Proposed Revision to Sargent & Lundy (S&L)
Topical Report SL-TR-1A
Quality Assurance (QA) Program

SARGENT & LUNDY LLC
NUCLEAR QUALITY ASSURANCE PROGRAM
TOPICAL REPORT
SL-TR-1A

REVISION 1516

Sargent & Lundy Management Organization Chart
Figure 01.01-1

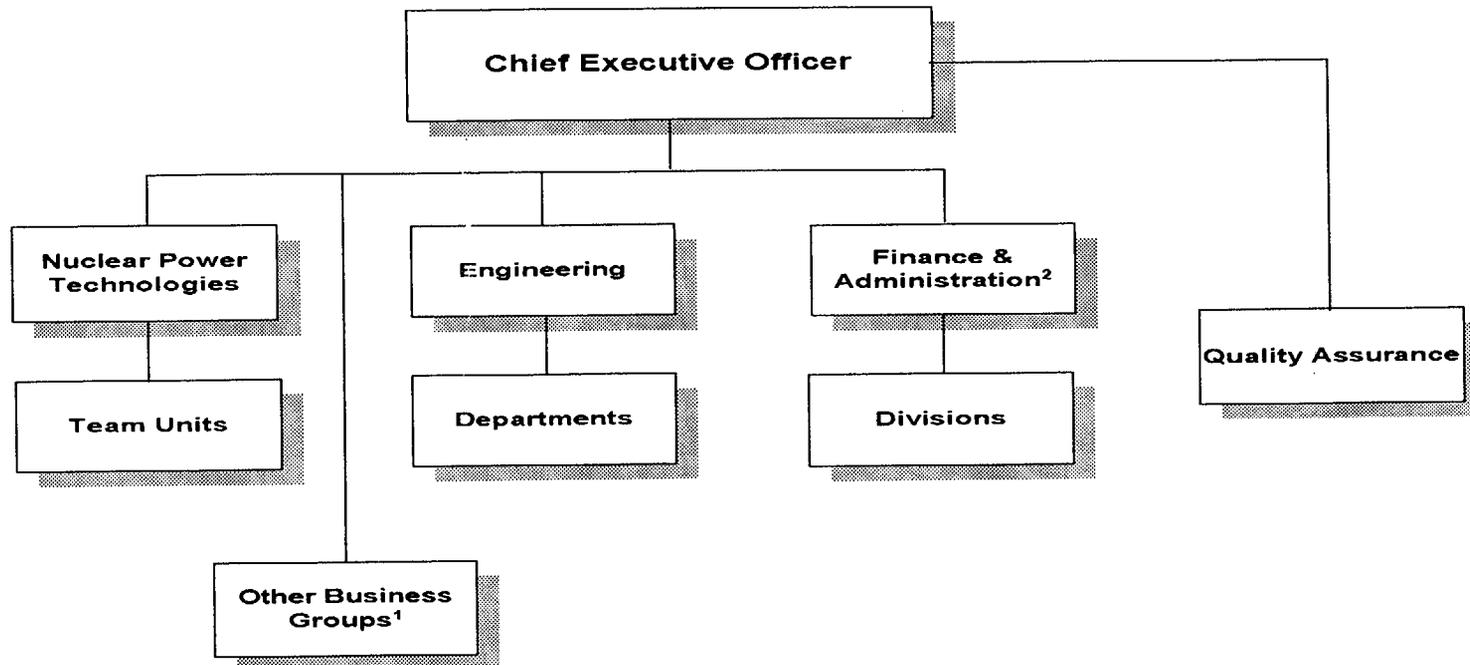
1. (Section 01.01) The former Diversified Business Group and Management Consulting Group have been replaced. The only part of the Diversified Business Group that performed work under this program was Operations & Maintenance Services (OMS). OMS is now part of the Plant Support Services Department, which in turn is part of the Engineering Functional Support Group (see page 01-2 of Revision 16 of this program). The Consulting Group, which superceded the Management Consulting Group, performs work outside the scope of this program, such as due diligence studies.

3. (Section 01.01) The Engineering, Technical Support Staff, and Material Management Departments of the Engineering Functional Support Group have been replaced by the Project Services and Plant Support Services Departments. The responsibilities of the former three departments have been transferred to the new two departments with the additional responsibilities of OMS.

19 S&L's management organizational structure is shown in
20 Figure 01.01-1, Sargent & Lundy Management Organization
21 Chart. Company services are organized into three business
22 groups and two functional support groups. The business
23 groups are Nuclear Power Technologies ~~Diversified~~
24 ~~Businesses and Management Consulting~~ and other business
25 groups as determined by the Chief Executive Officer. The
26 functional support groups are Engineering and Finance &
27 Administration. ~~Each group is managed by a Director who~~

12 ~~The Director of Diversified Businesses exercises~~
13 ~~administrative control over personnel and management~~
14 ~~resources providing information technology services,~~
15 ~~transmission and distribution services, and operations &~~
16 ~~maintenance services.~~

17 ~~The Director of Management Consulting oversees management~~
18 ~~consulting engagements that provide domestic government and~~
19 ~~industry association services. In a similar fashion, the~~
20 ~~Directors of the other business groups oversee services~~
21 ~~provided within their areas of responsibilities.~~

11 The Director of Engineering exercises administrative control
12 over the *Project Services and Plant Support Services*
13 ~~Engineering, Technical Support Staff, and Material~~
14 ~~Management Departments.~~
